## ADDENDUM # 009

**Date:** 05/14/18

**RE:** Cherokee Nation Entertainment  
Tahlequah Casino

***Item 1***    Structure Summary of Changes

SHEET NUMBER: S4.8

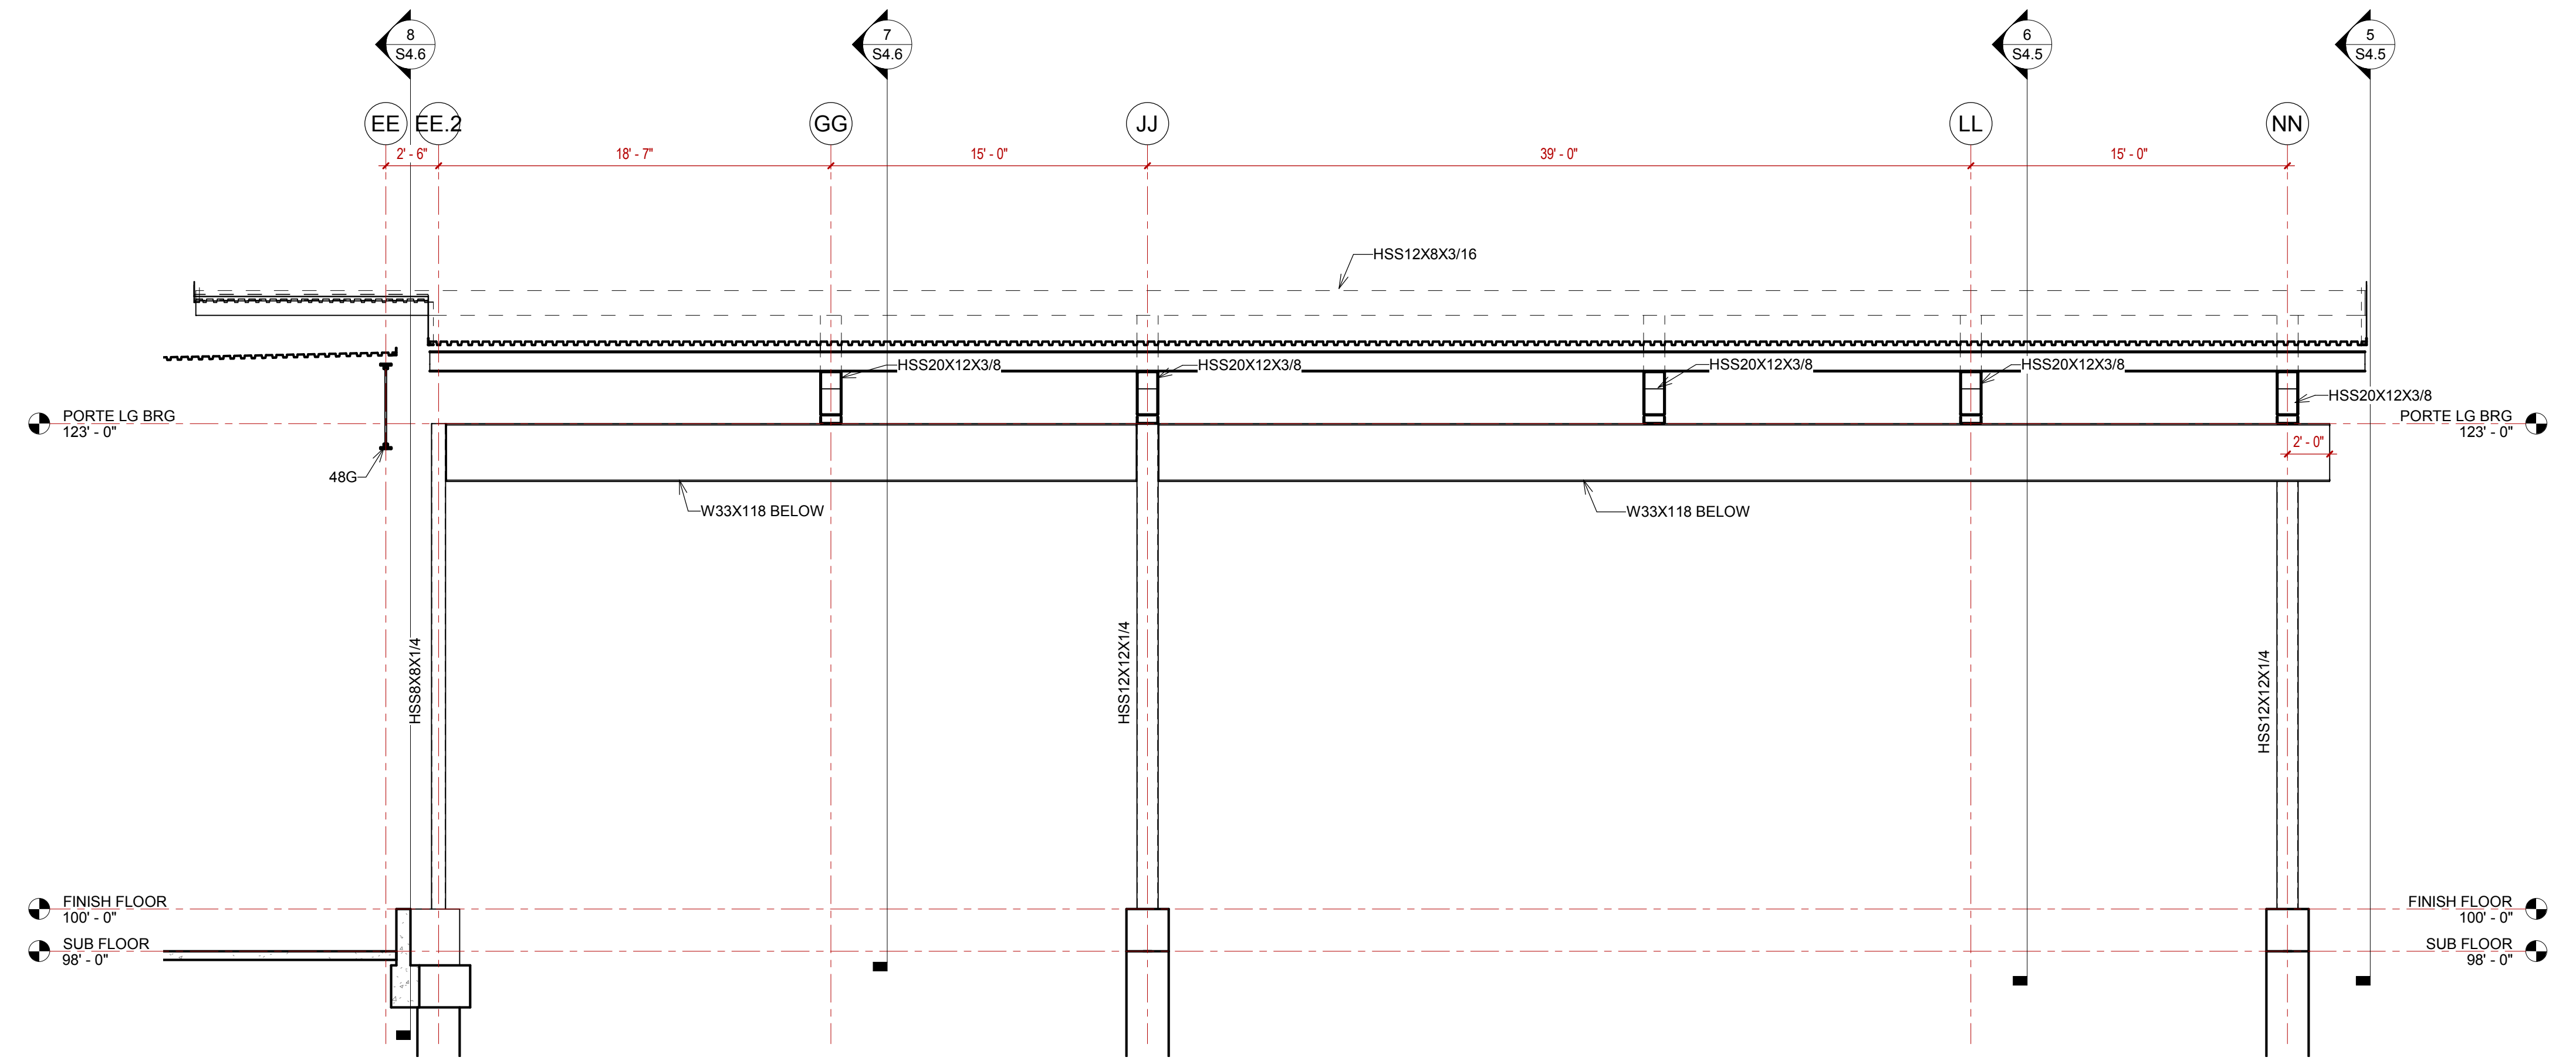
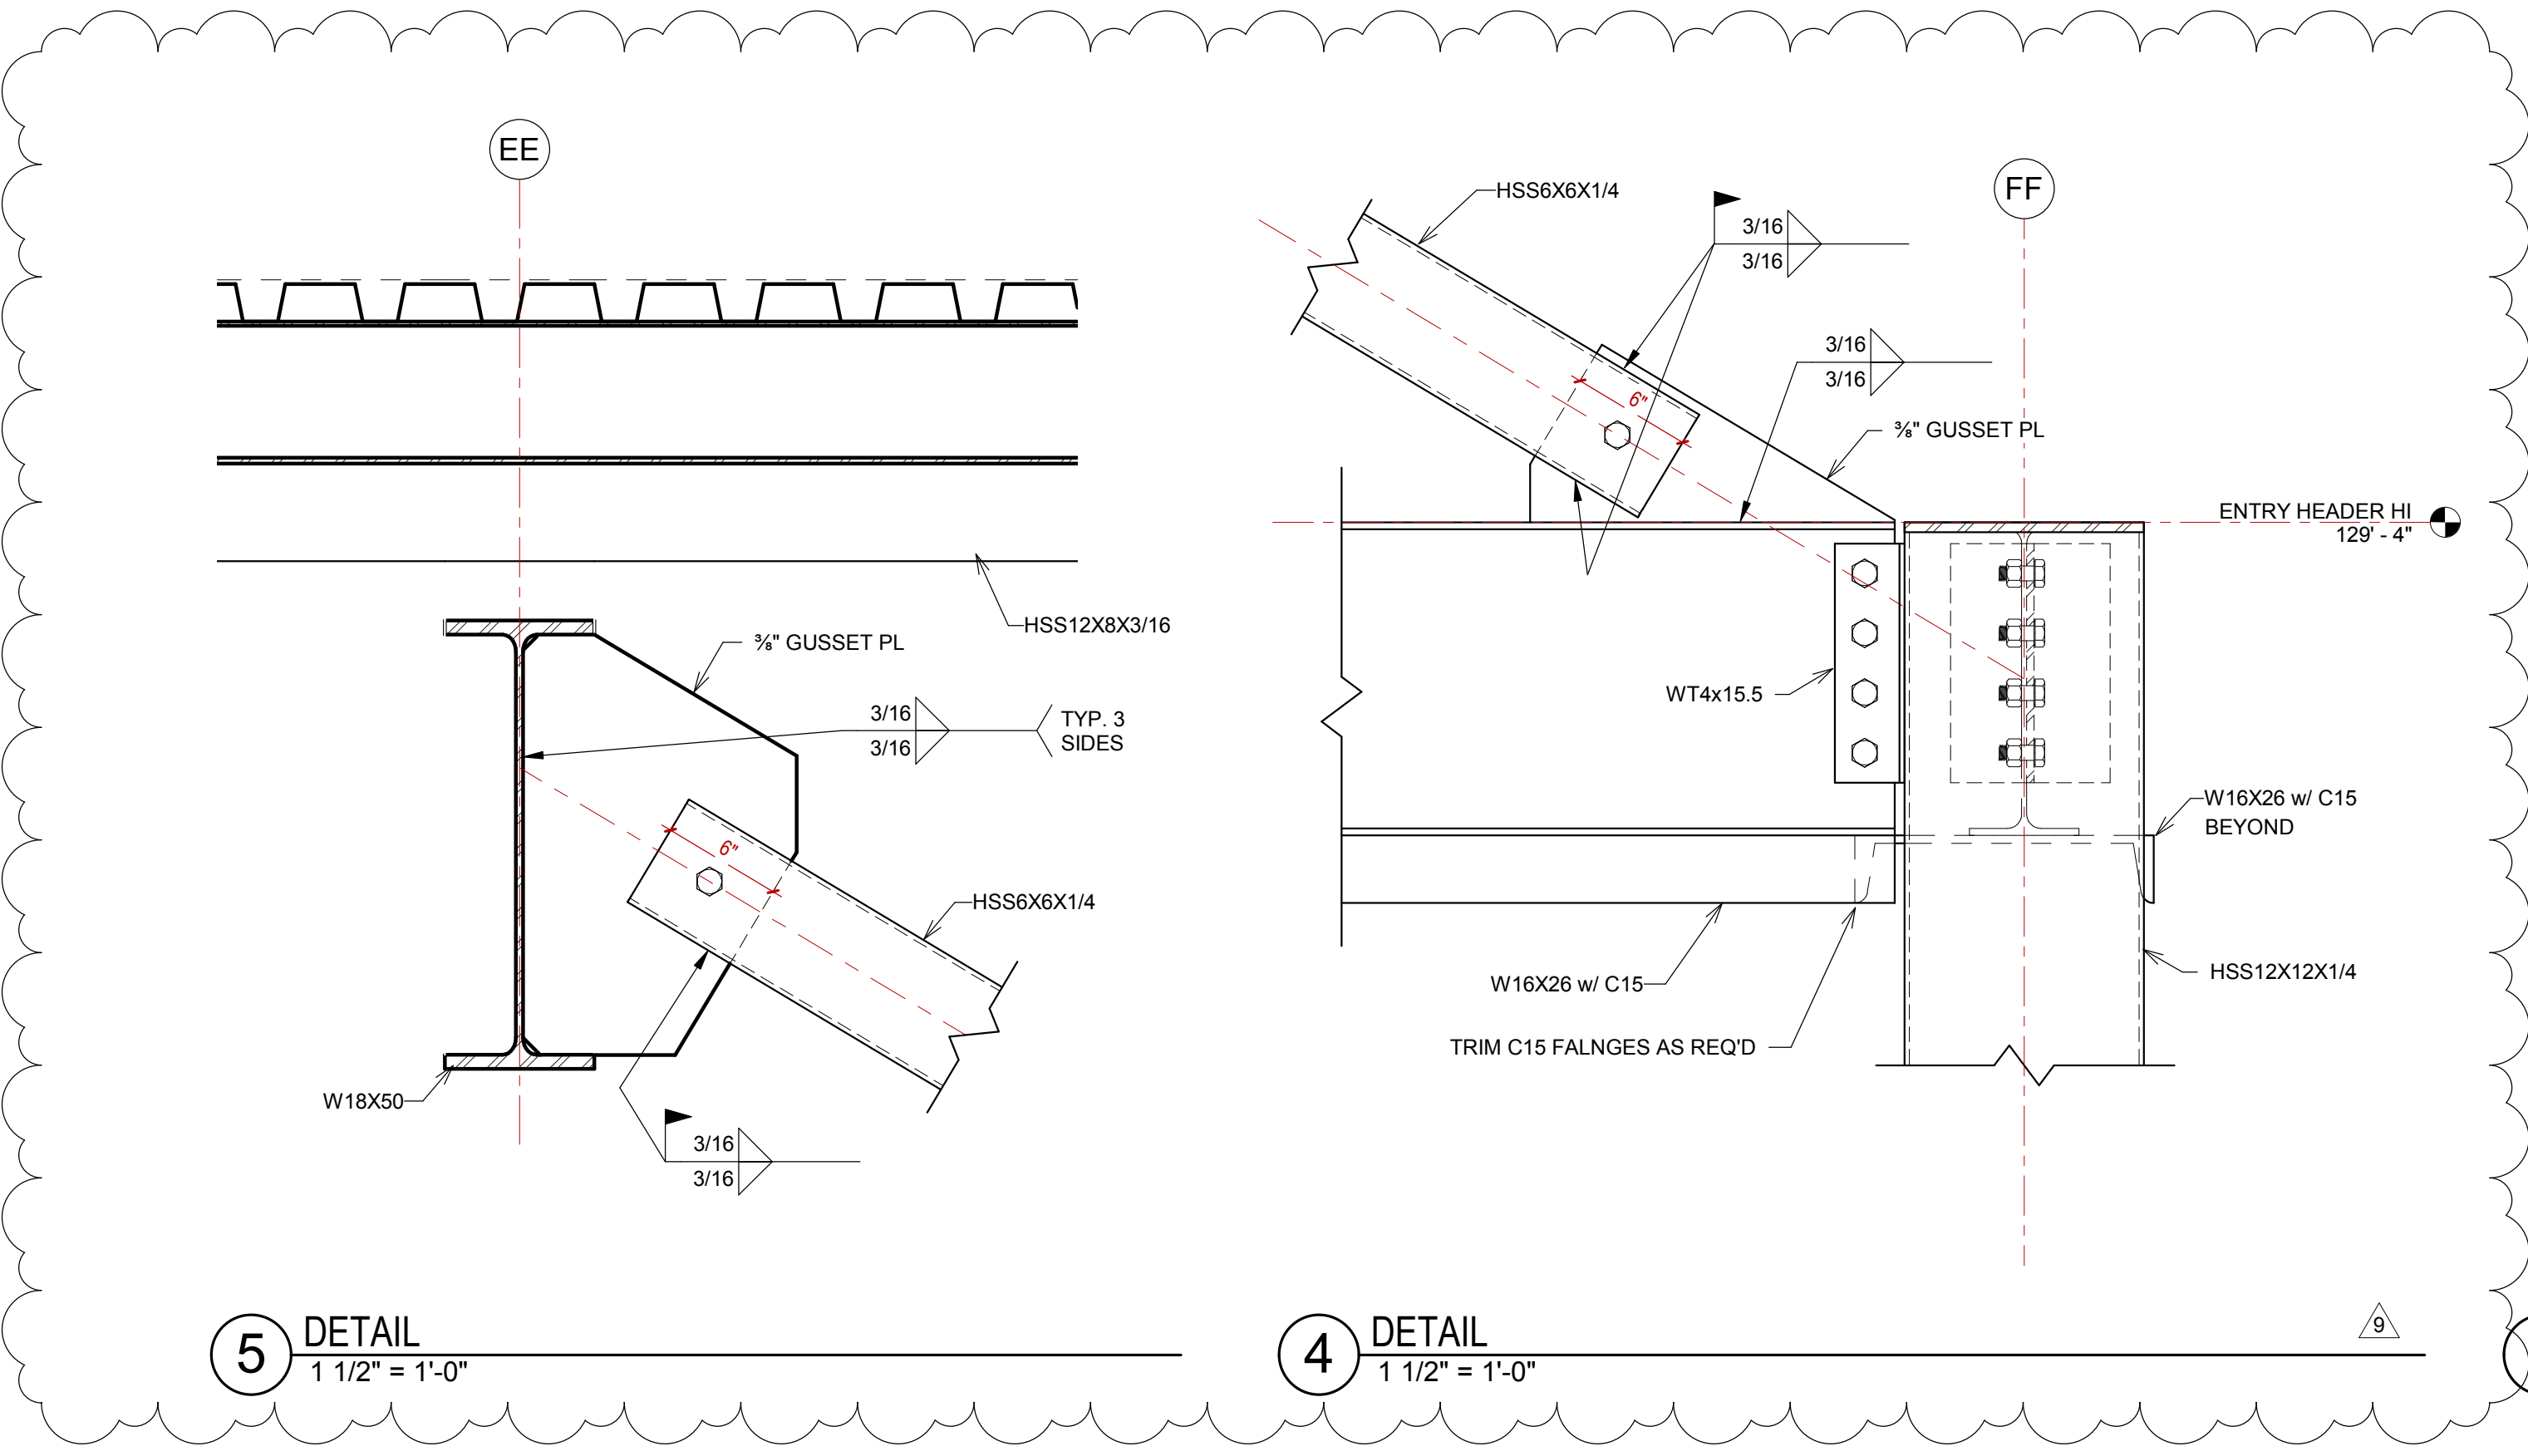
Sheet No.	Addendum
S3.2	<ul style="list-style-type: none"><li>• Moved roof joists at Grid 30.</li><li>• Added column brace at Grid 31.</li></ul>
S4.7	<ul style="list-style-type: none"><li>• Added diagonal brace at main entry porte-cochere</li></ul>
S4.8	<ul style="list-style-type: none"><li>• Added diagonal brace at main entry porte-cochere, grids 30 &amp; 31</li></ul>
S5.2	<ul style="list-style-type: none"><li>• Revised bar joist seat connections (5/S5.2)</li><li>• Deleted the JG to WF web connection (4/S5.2)</li></ul>
S5.3	<ul style="list-style-type: none"><li>• Added the revised JG to WF web connection.</li><li>• Added column brace detail.</li></ul>
